# HISTORIC AND DESIGN REVIEW COMMISSION

**HDRC CASE NO:** 2024-323  
**ADDRESS:** 509 MADISON ST  
**LEGAL DESCRIPTION:** NCB 749 BLK 8 LOT 3 EXC N IRR 7.13 FT AND EXC W IRR 2.5 FT  
**ZONING:** RM-4, H, RIO-4  
**CITY COUNCIL DIST.:** 1  
**DISTRICT:** King William Historic District  
**APPLICANT:** Christopher Rocha/Master Contracting  
**OWNER:** BICOASTAL VENTURES LLC  
**TYPE OF WORK:** Carport Construction  
**APPLICATION RECEIVED:** September 12, 2024  
**60-DAY REVIEW:** November 11, 2024  
**CASE MANAGER:** Caitlin Brown-Clancy

## REQUEST:

SHEET:  
**A-0.1**

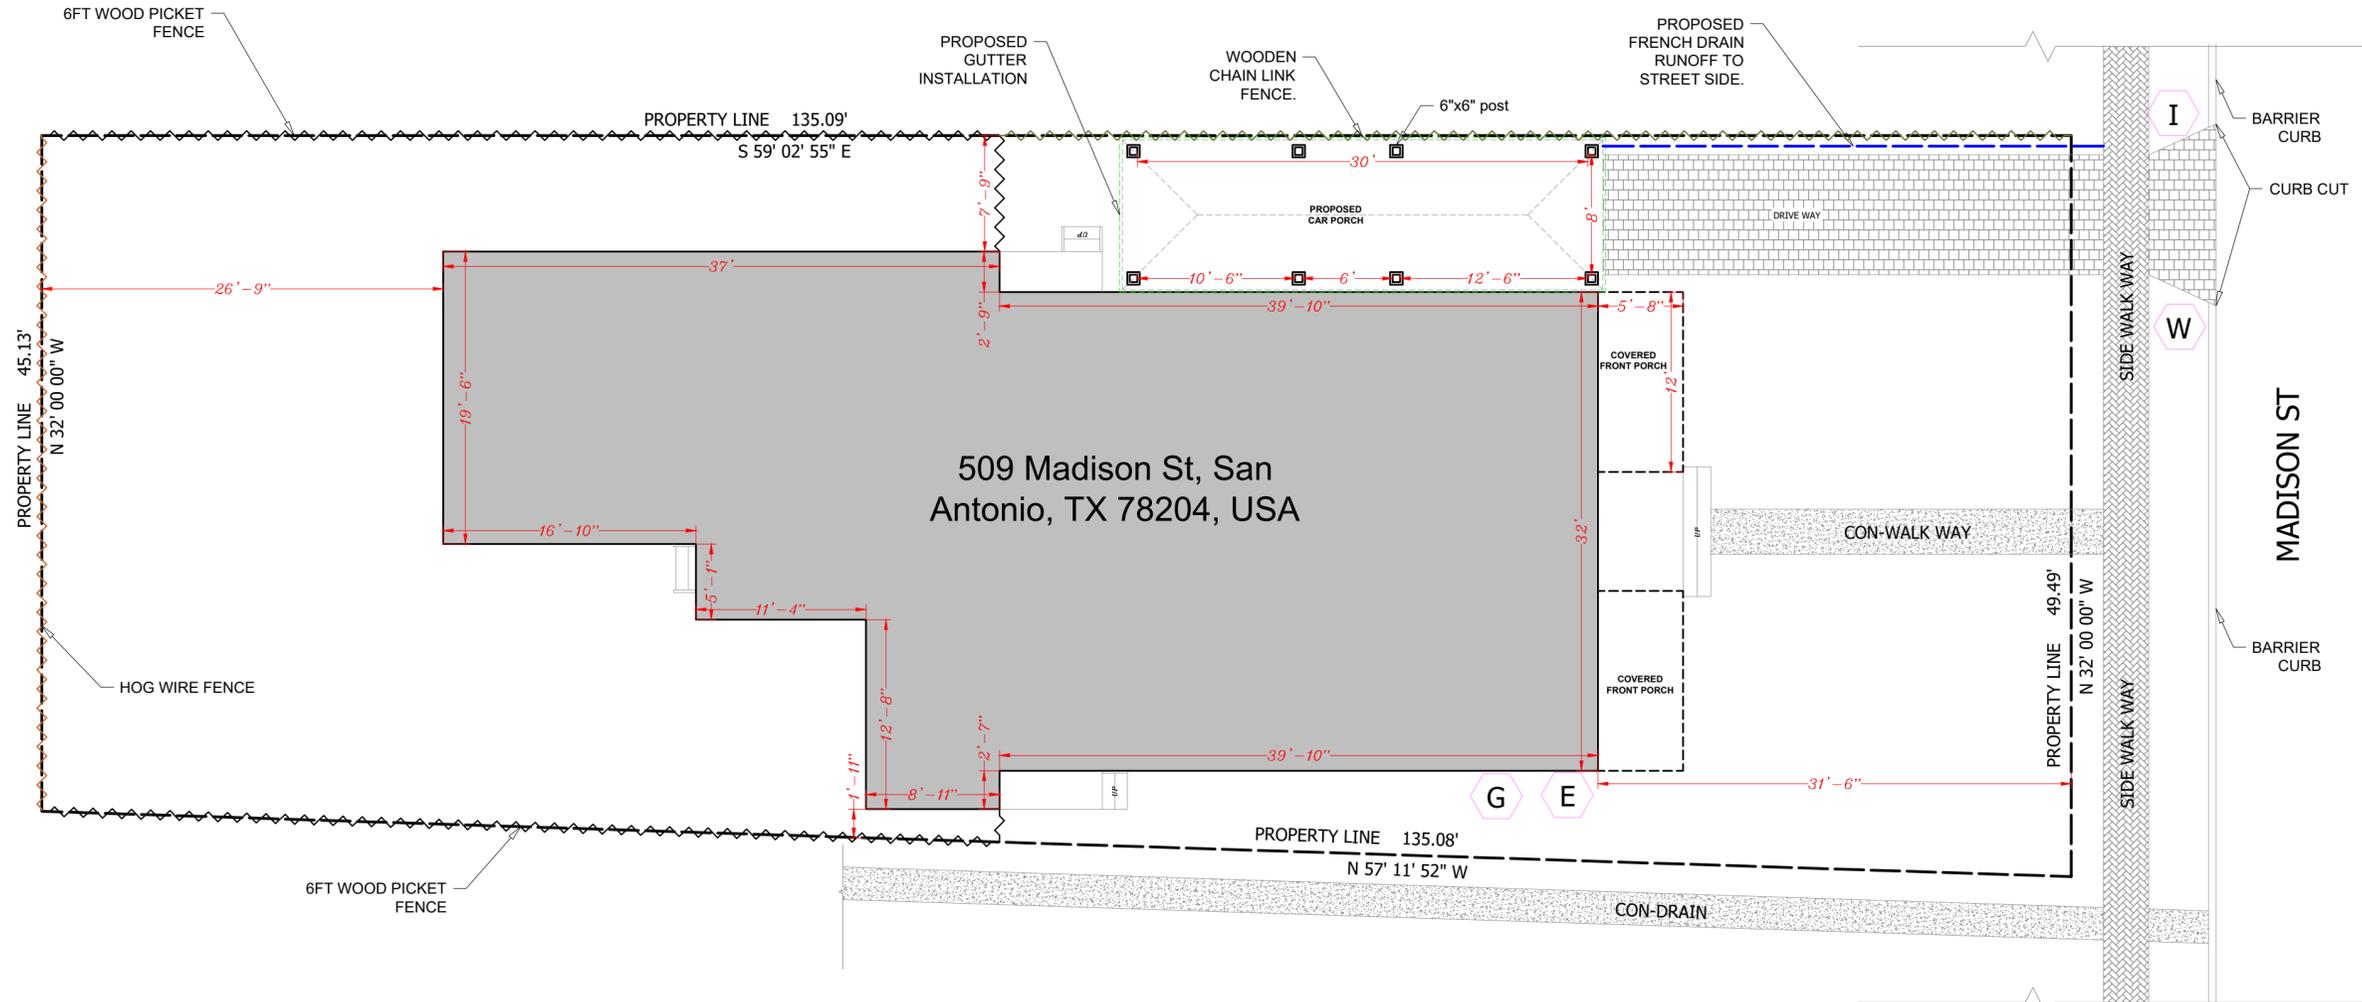
- c. **CARPORT: SETBACKS** – The applicant has submitted drawings proposing two separate setbacks to for the new accessory structure. Guideline 5.B.ii for new construction stipulates that new garages and outbuildings should follow the historic orientation and setbacks common in the district. The applicant is responsible for complying with all zoning setback standards and filing for a variance with the Board of Adjustment if applicable. Staff finds the carport should be set back fully behind the front wall plan of the primary structure in order to conform to the Guidelines. Staff additionally finds a carport that encroaches into the side yard at this location is not appropriate because there is no precedent for a non-conforming structure at this location.

Staff does not recommend either carport option at this location based on the findings. If the HDRC finds that a carport is appropriate, staff recommends the following stipulations be considered.

- 1.The freestanding, wood construction carport design is preferred over the metal option.
- 2.That the carport be set behind the front façade wall plane and reduced in length to accomplish this stipulation.
- 3.That fully dimensioned and to-scale drawings that meet the requirements be submitted to staff to receive a Certificate of Appropriateness (COA).
